SECTION 00 91 15

ADDENDUM NUMBER 6

- 1.01 DATE: JANUARY 22, 2021**
- 1.02 PROJECT: ELMORE SPORTS MEDICINE RENOVATIONS**
- 1.03 PROJECT NUMBER: DCM NO. 2020452; PSCA NO. 2018**
- 1.04 OWNER: ALABAMA A&M UNIVERSITY**
- 1.05 ARCHITECT: NOLA | VAN PEURSEM ARCHITECTS, PC**

BOILER REPLACEMENT, ALTERNATE #1
MECHANICAL ROOM DEMO PLAN
SCALE: 1/8" = 1'-0"

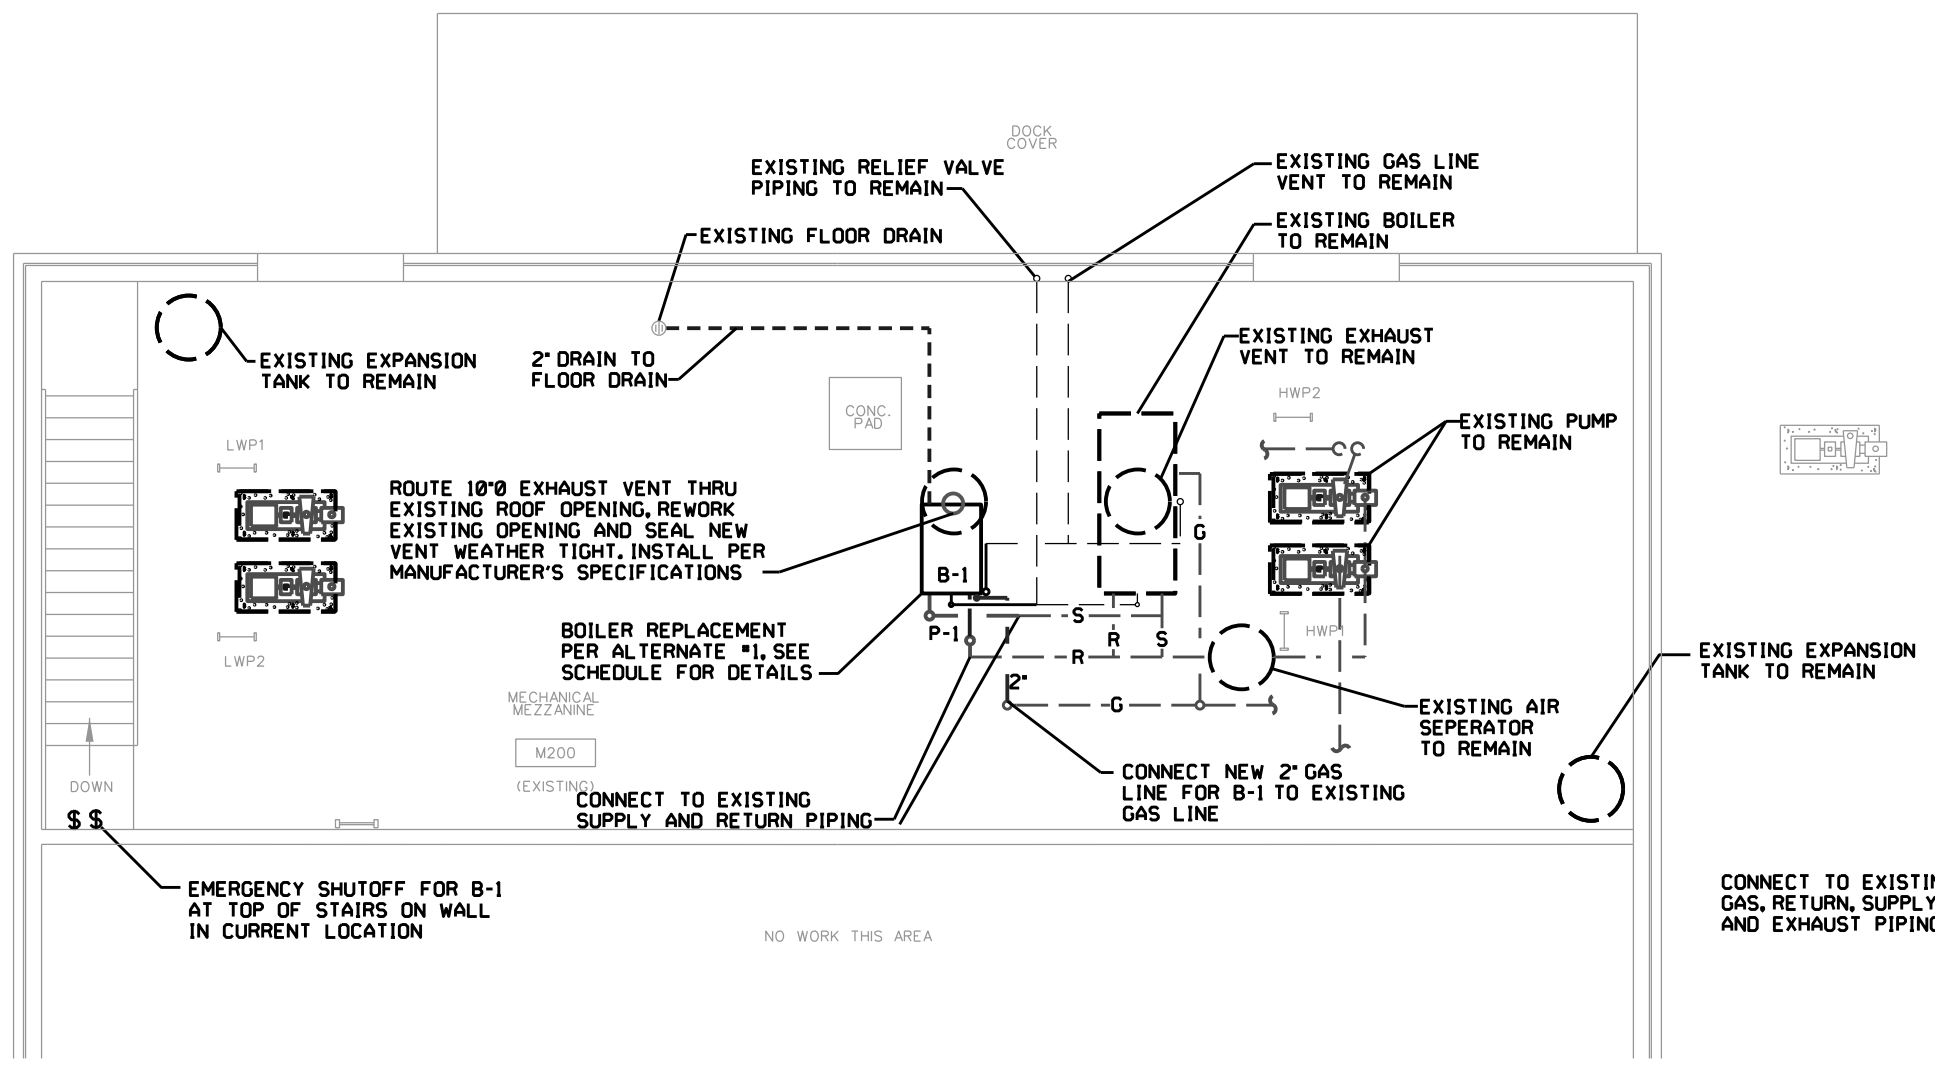
- A. Replace this sheet in its entirety. Revisions include the following:
 1. Revisions to the duct layout & fire damper locations on the Partial Mezzanine Plan

AD6-M-2-01

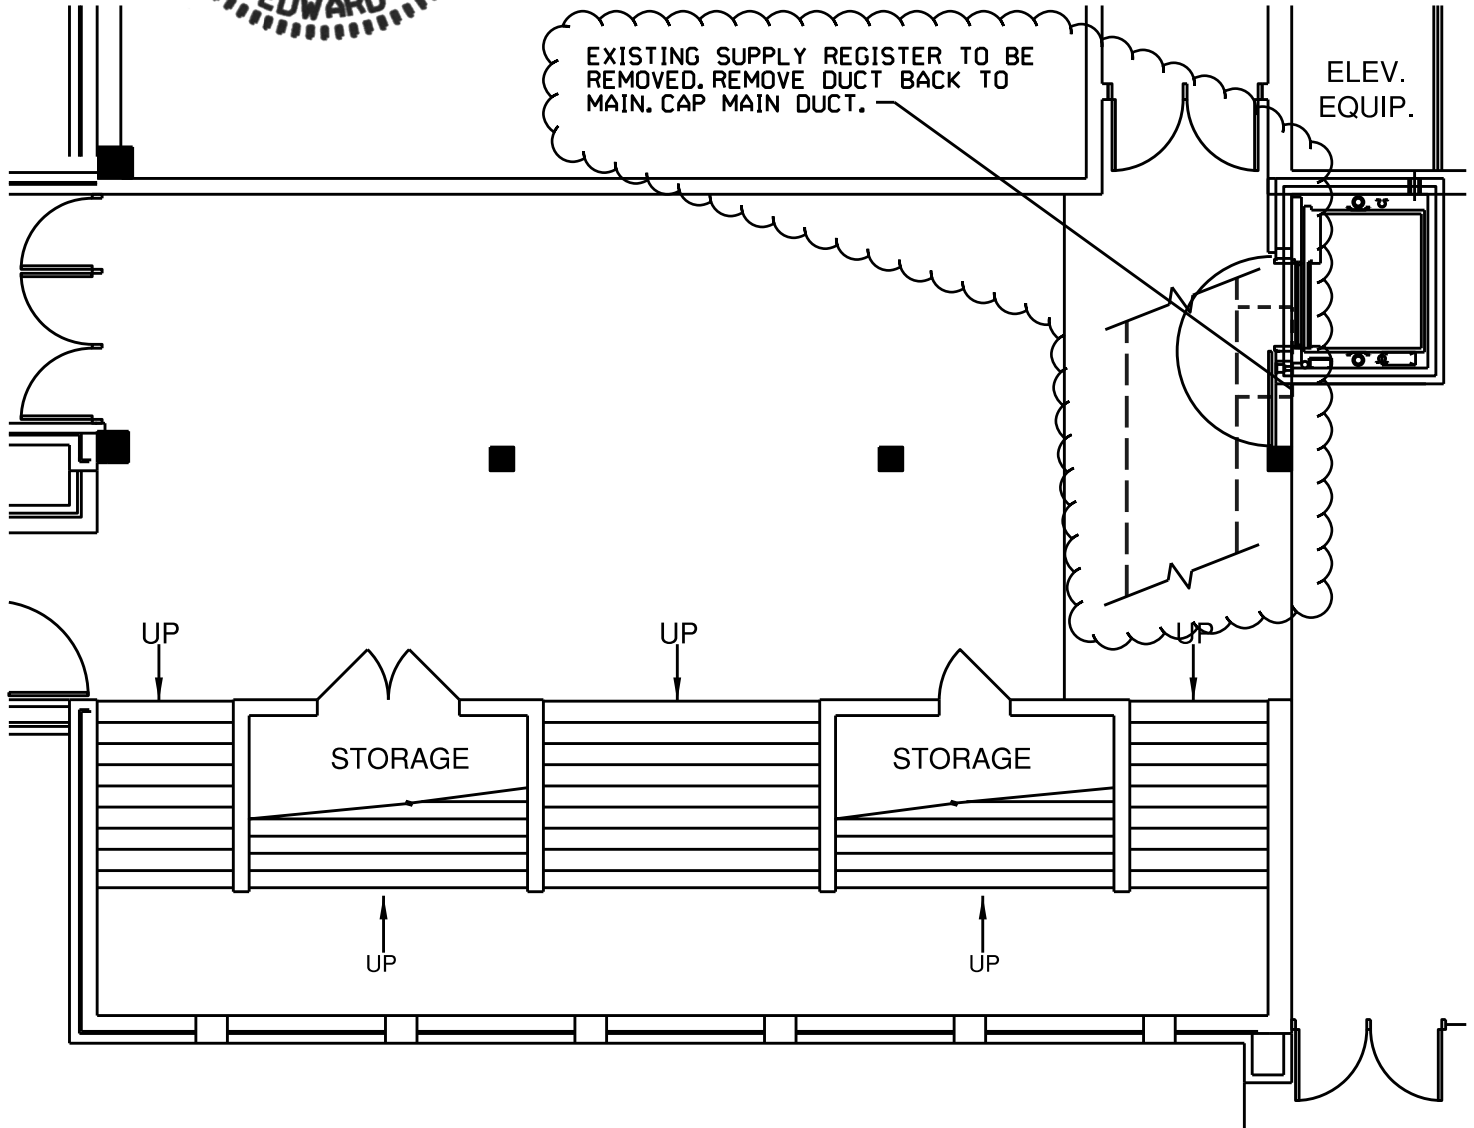
- A. Revise ductwork on ground floor near new elevator per attachment AD6-M-2-01.
- B. Revise ductwork on ground floor at structural floor repairs in the Sports Medicine Training Area per attachment AD6-M-2-02.
- C. Add the following note for the A/C unit mounting:
 1. Contractor to provide roof support for flat roof as required per code and manufacturer for Heat pump portion of split system. Contractor will verify exact roof type before bidding.

SHEET NUMBER
E-2
OF
2

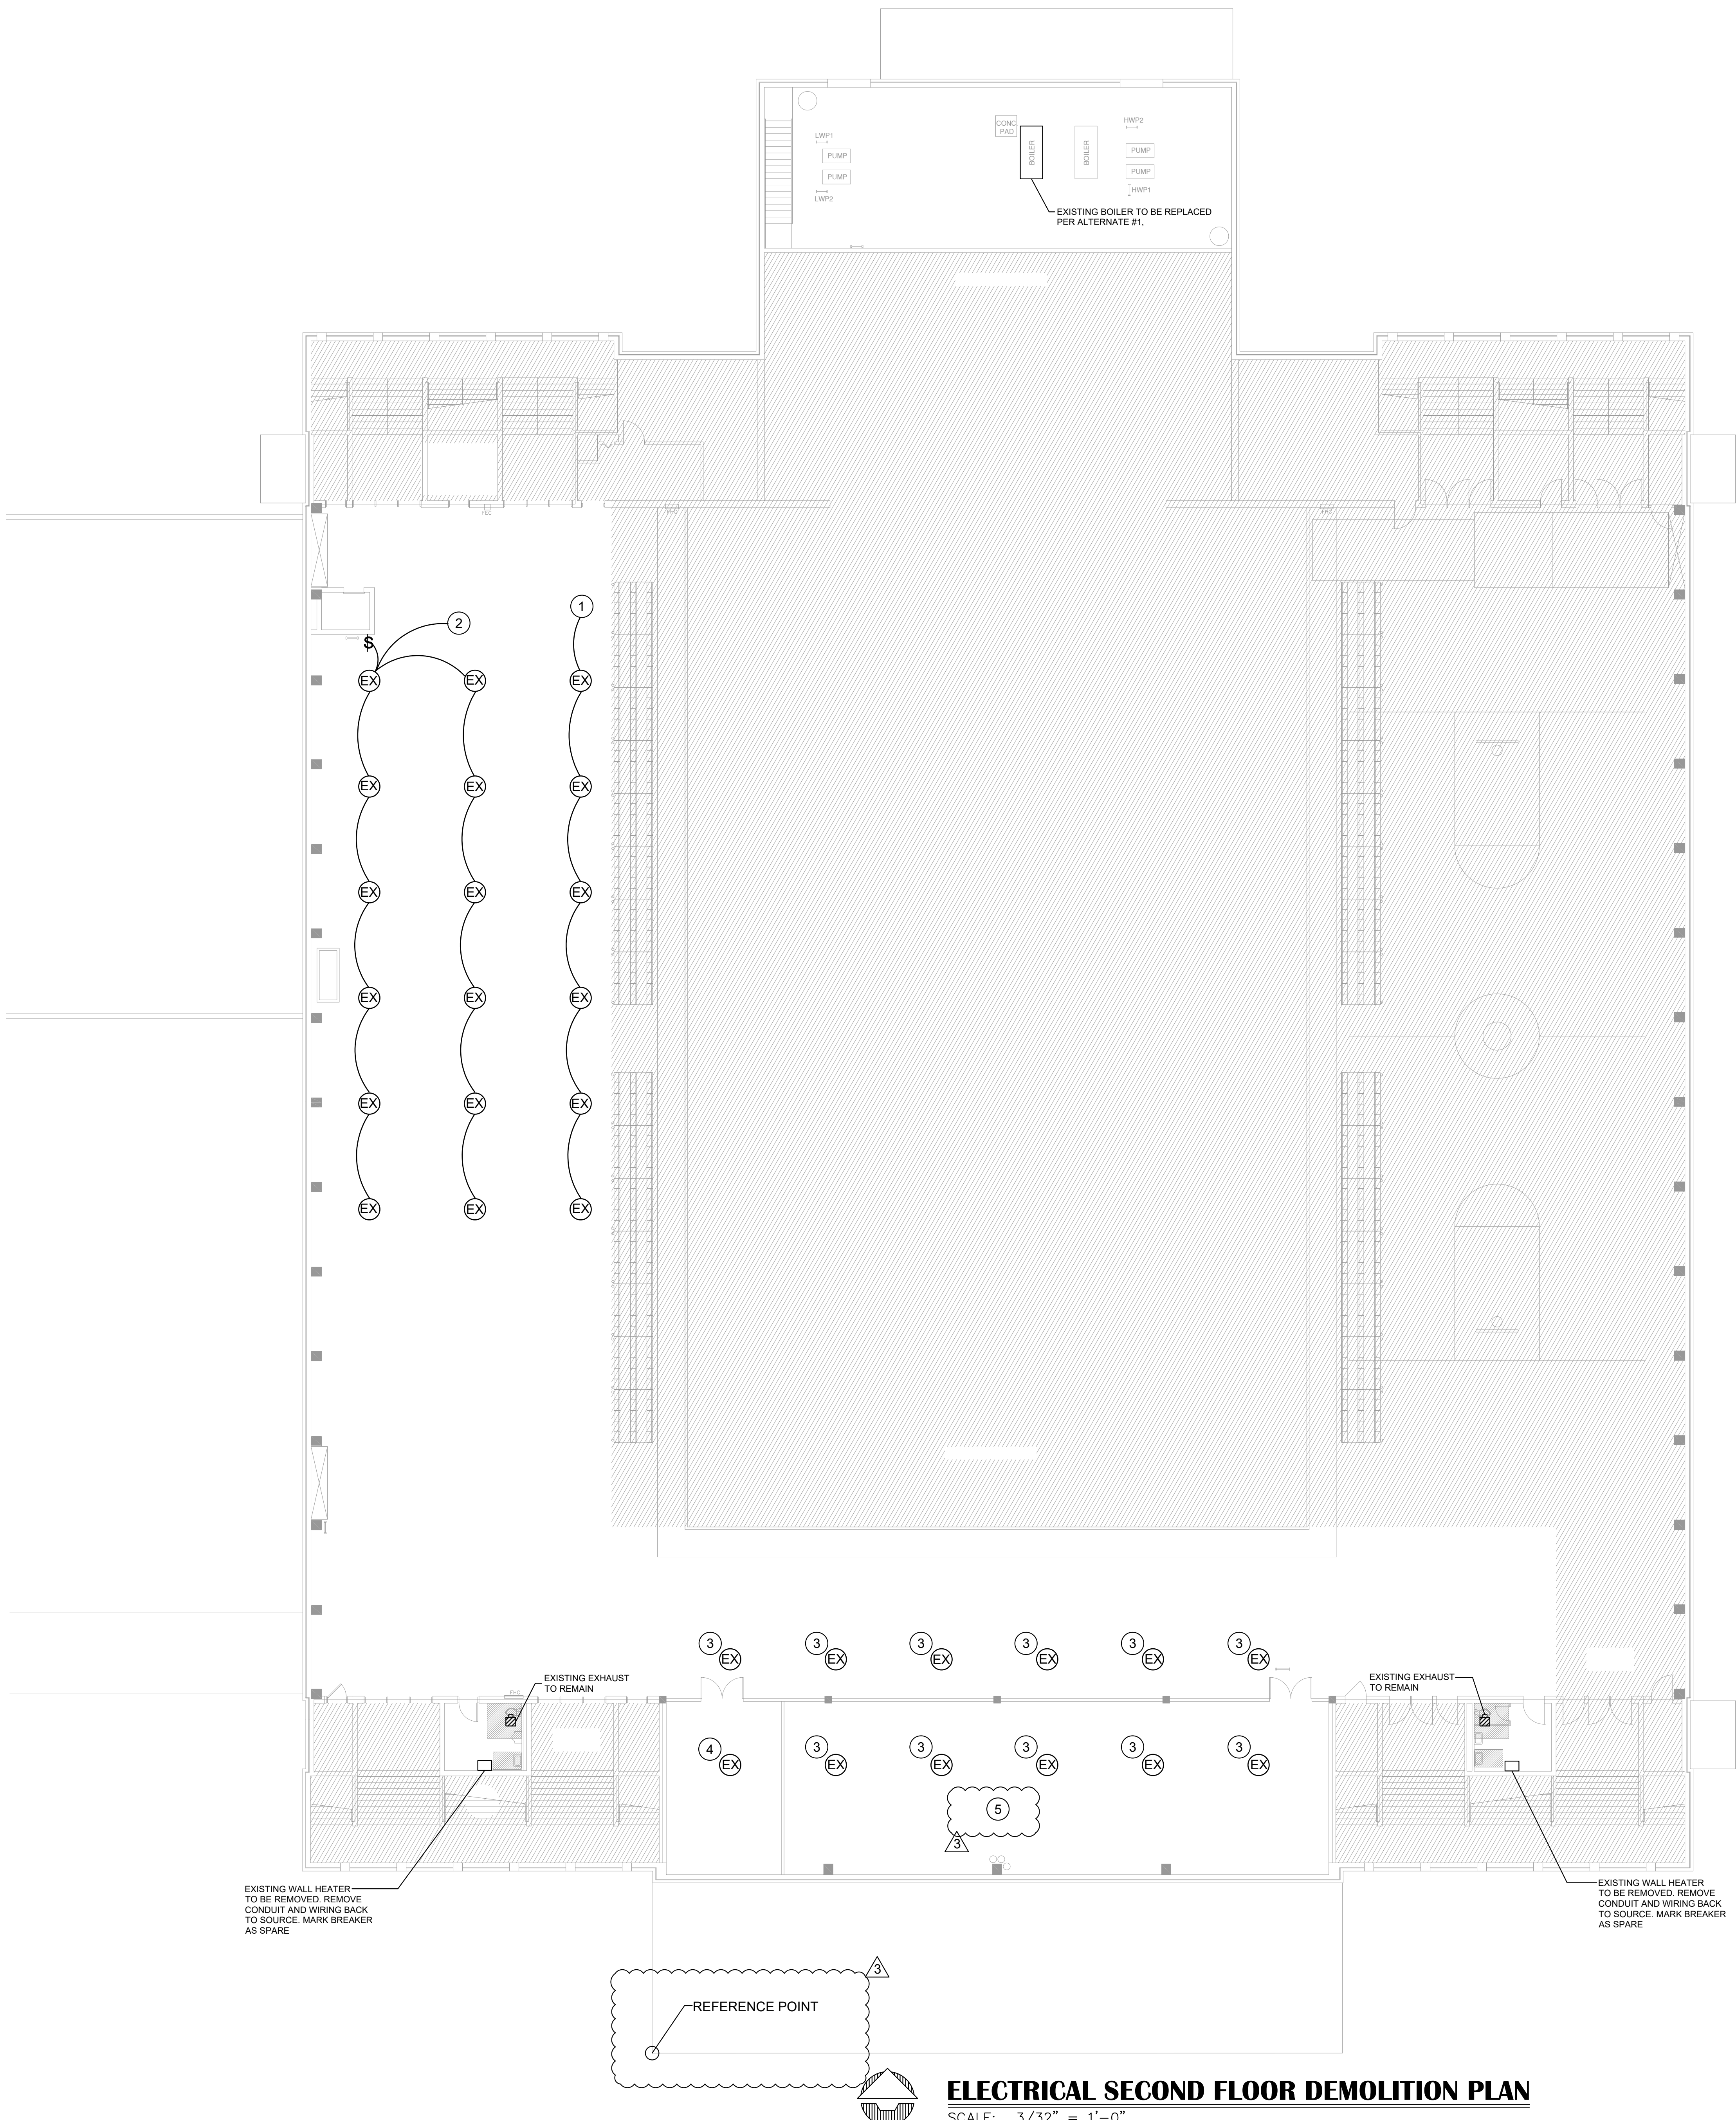
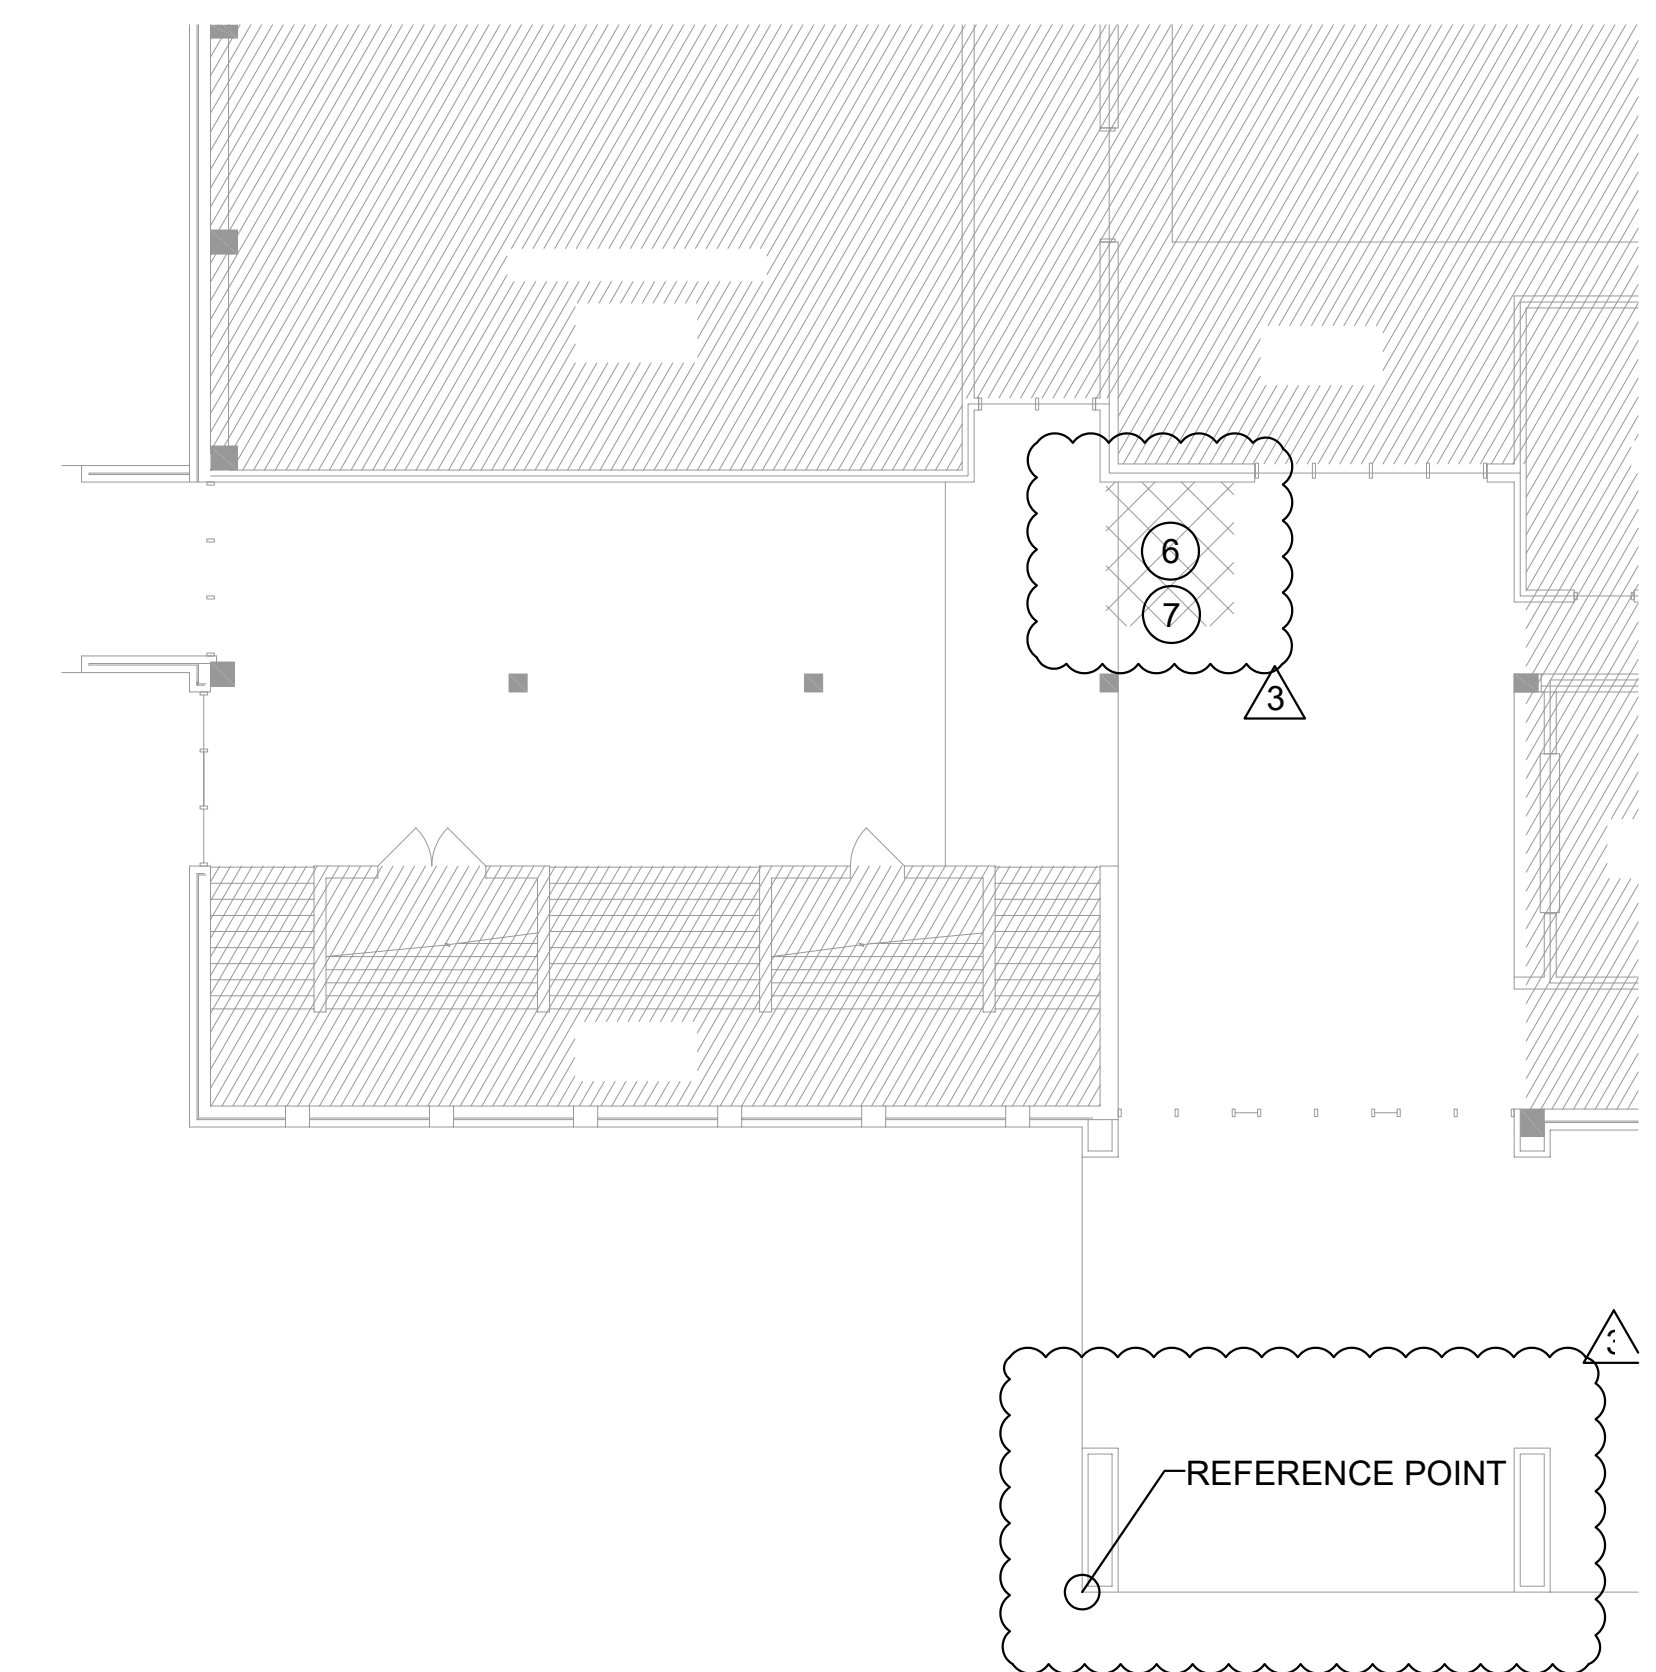
- A. Replace this sheet in its entirety. Revisions include the following:
 1. Added Partial First Floor Plan @ New Elevator Location.
 2. Added Reference Points.
 3. Added Electrical Lighting Demolition Keyed Notes 5, 6, and 7.
